**LANDMARK COMMISSION**

FILE NUMBER: COA-26-000162  
LOCATION: 3500 Latimer St.  
STRUCTURE: Non-Contributing  
COUNCIL DISTRICT: 7  
ZONING: PD-595

**REQUEST(S)**

To construct a new main residential building (on a vacant corner lot) with an accessory structure -- a rear detached two-car garage.

COURTESY REVIEW RECOMMENDATION FORM

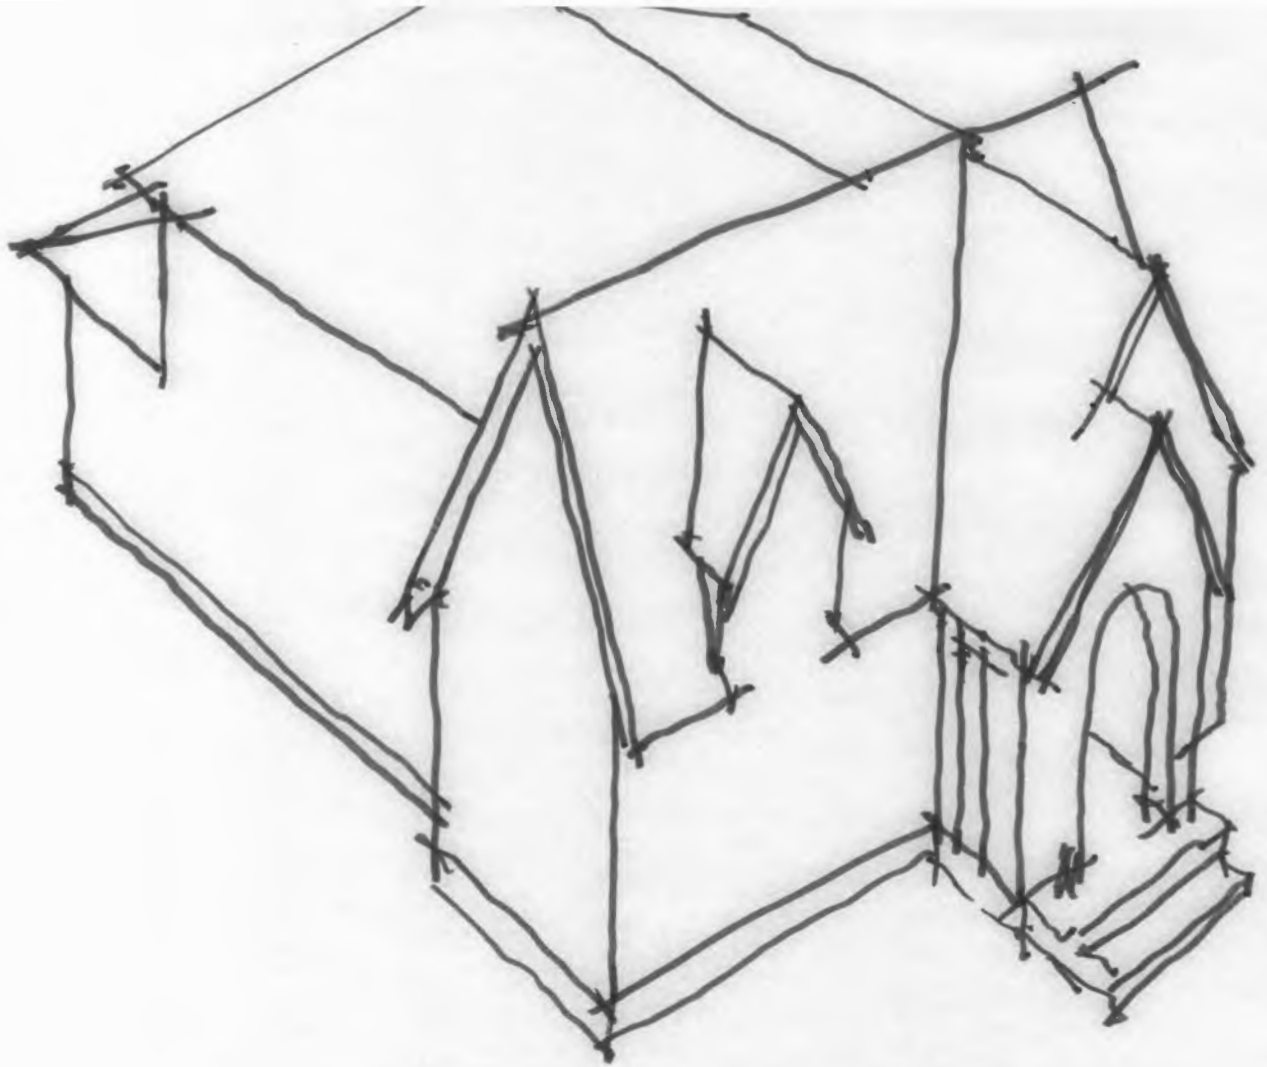
1. REFER SKETCH ATTACHED TO REDUCE SCALE TO 1 1/2 STORIES FROM THE STREET.
2. ADD WINDOWS ON RIGHT WALL IN THE STAIRWELL
3. ALIGN WINDOWS IN LIVING & BEDROOM ON LEFT WALL.
4. LOWER THE PORCH ROOF
5. ON DORMER, MATCH THE SLOPE OF OTHER GABLE ON FRONT ELEVATION
6. COPY BRICK DETAILS OF TUDOR REVIVALS ON ROMINE AVE.

**2 WEST ELEVATION - (FRONT)**  
3/8" = 1'-0"

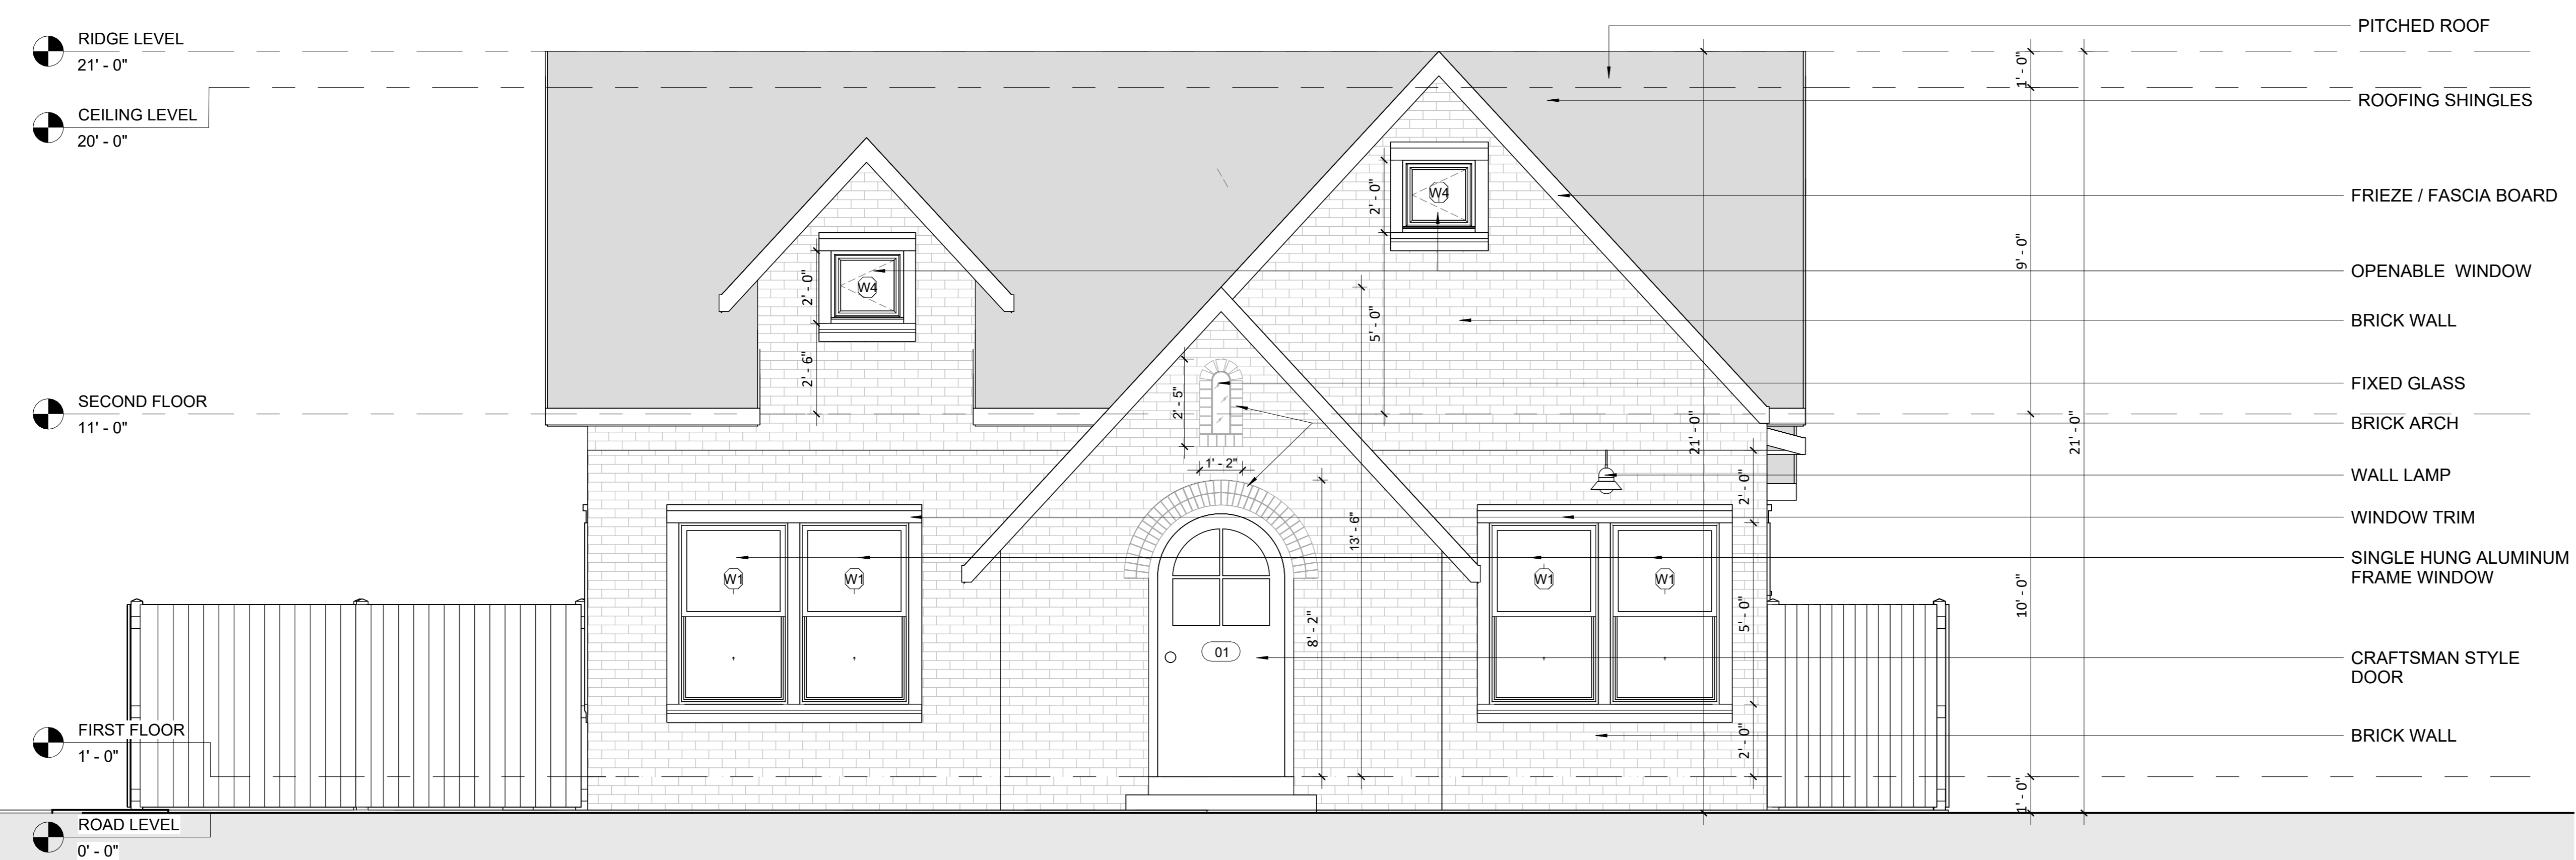
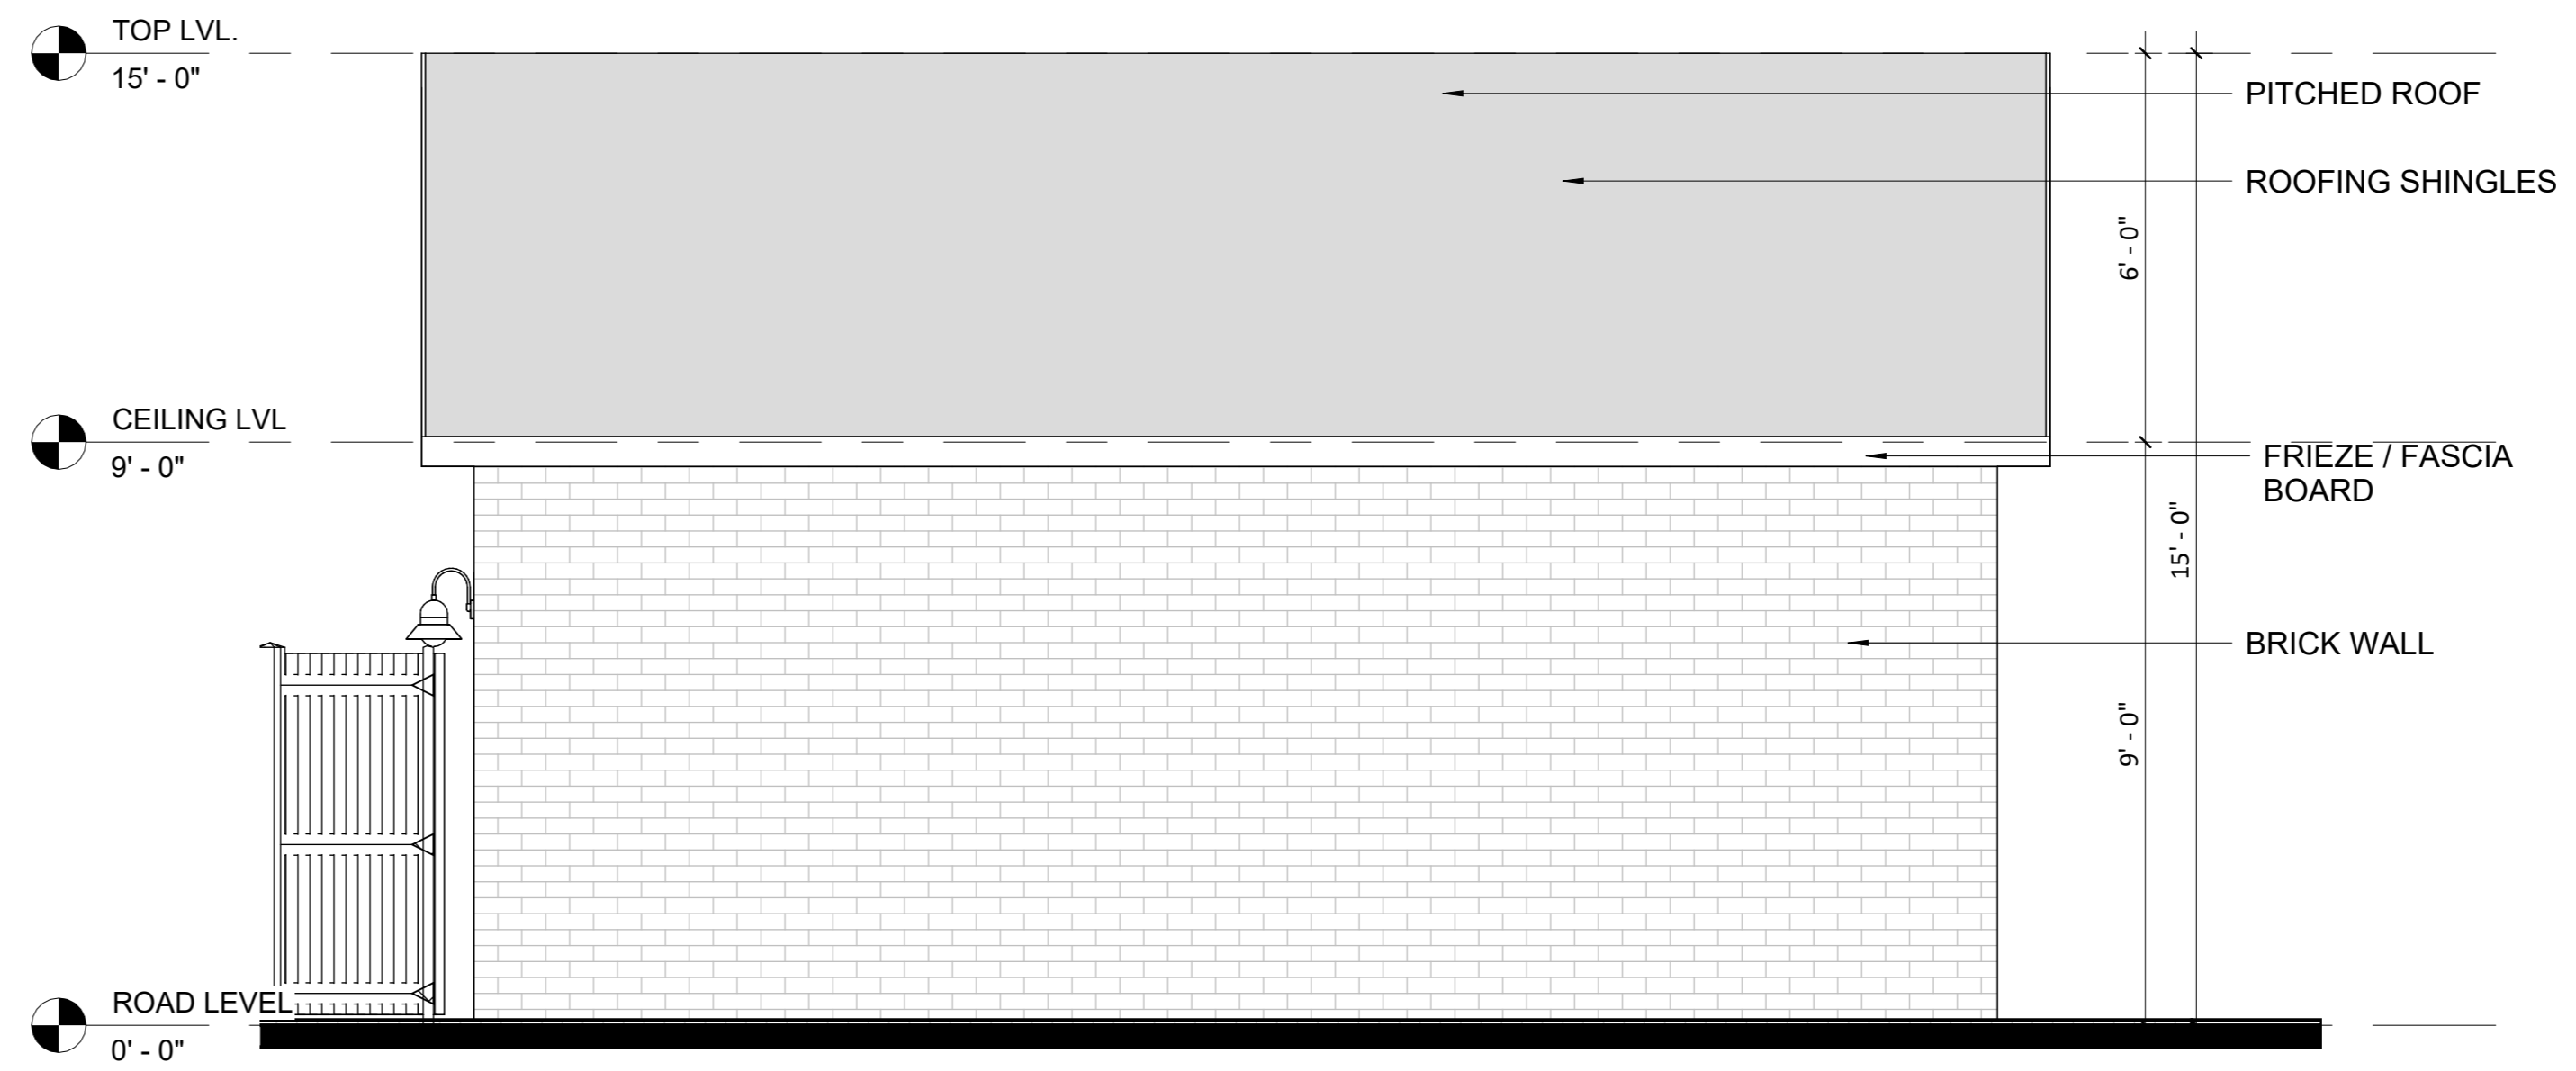
No quorum – Comments only. Non-Supportive, with the following comment(s): the design shown is not what the Landmark Commission recommended. It lacks important architectural features characteristic of the Tudor Revival style.

That the request for a Predesignation Certificate of Appropriateness to construct a new main residential building (on a vacant corner lot) with an accessory structure – a detached two-car garage be approved in accordance with drawings and specifications dated 4/15/2026 with the following conditions: (1) that the exterior cladding be brick veneer (unpainted); (2) that an exterior (masonry) chimney be added to the front or cornerside elevation; (3) that roof pitch be steeper – minimum 12:12; (4) that windows be all aluminum (no cladding) with lite configuration of one-over-one; (5) that front door be arched or rectangular with heavy timber styling and decorative strap hinges; and (6) that driveway(s), walkway(s) and steps be of brush finished concrete. Implementation of the recommended conditions would allow the proposed work to meet the standards in City Code Section 51A-4.501(d)(5)(B) for noncontributing structures; and the Secretary of the Interior’s Guidelines for Setting (District/Neighborhood).
